**To: All Vendors Bidding on The College of New Jersey
STEM MEP Modifications Project**

ADDENDUM NO. 1

REFERENCE: The College of New Jersey
STEM MEP Modifications Project
Bid No. AB190029

STEM BUILDING & CHEMISTRY ADDITION
GROUND FLOOR PIPING PLAN

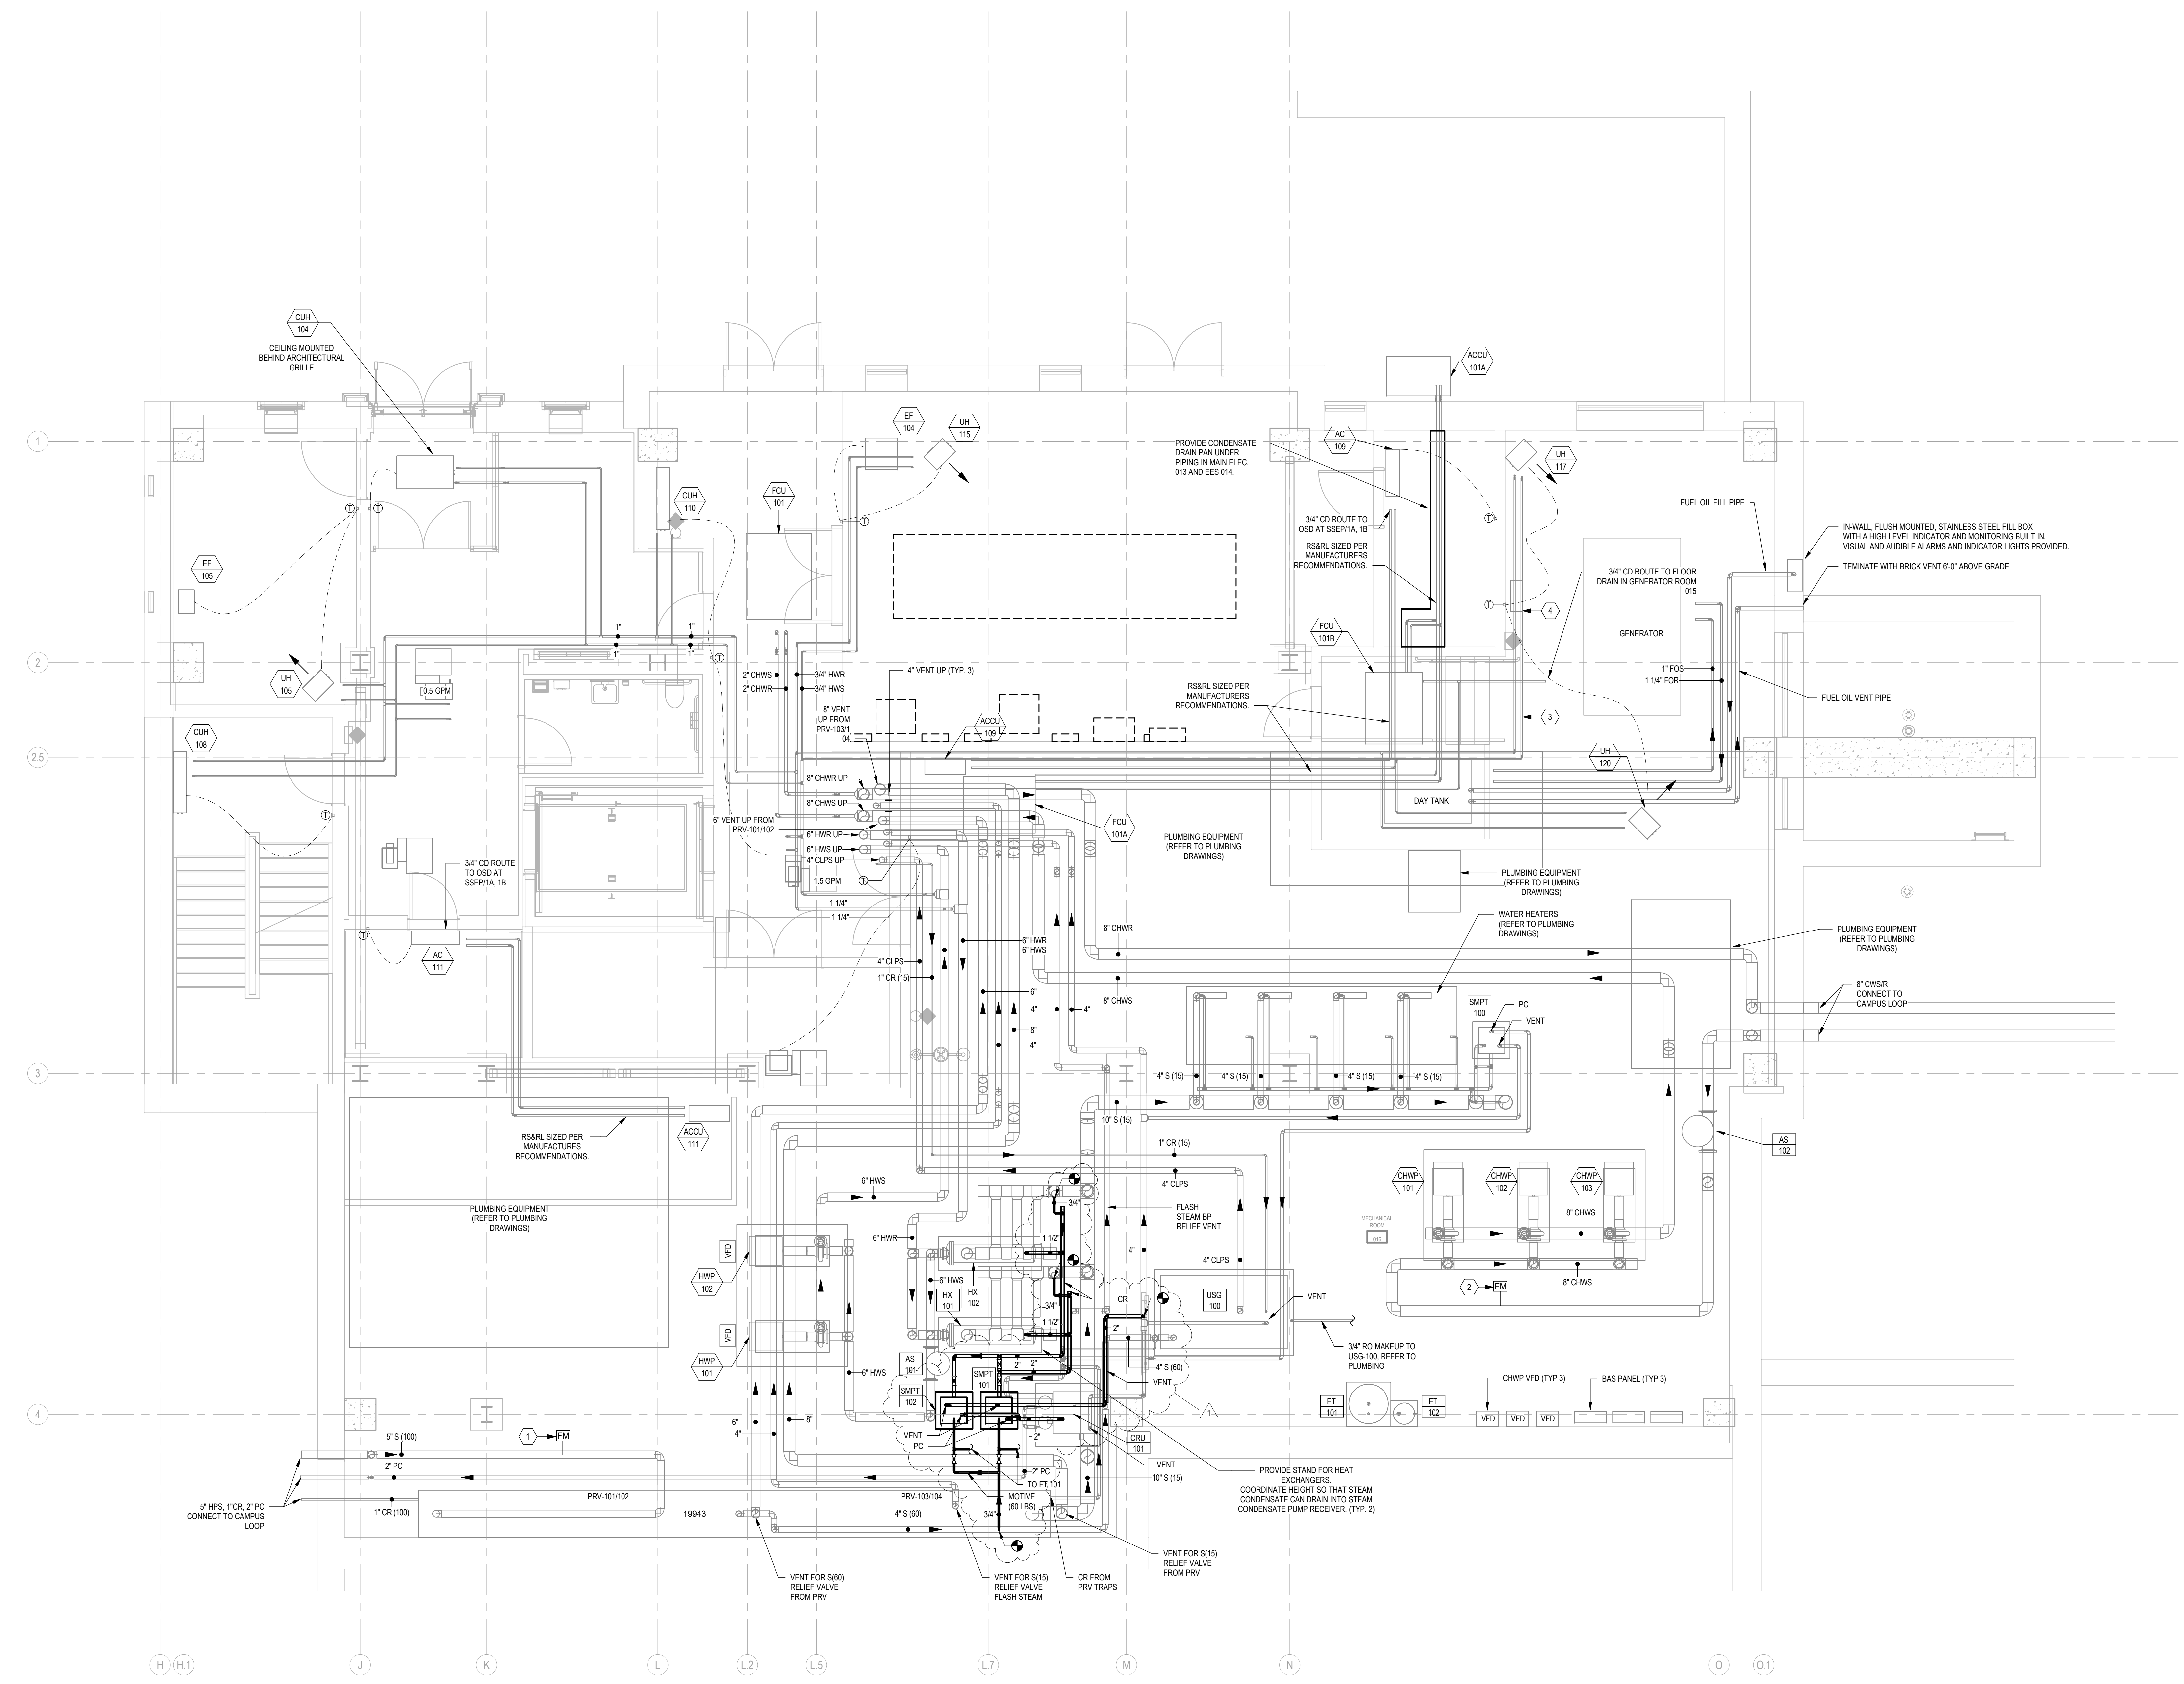
Answer: The clouded note on the drawing should read "9" in lieu of "8" to match note "9" in the Keynote Legend.
2. Drawing M401, can a plan view drawing be provided to show location and piping arrangement for SMPT 101 & 102?

Answer: See attached sheet M200 for a plan view.
3. Bulletin #28 references drawing M401C but there is no drawing M401C in the bid package. Can a plan drawing be provided as requested in #2 above for SMPT 201 & 202?
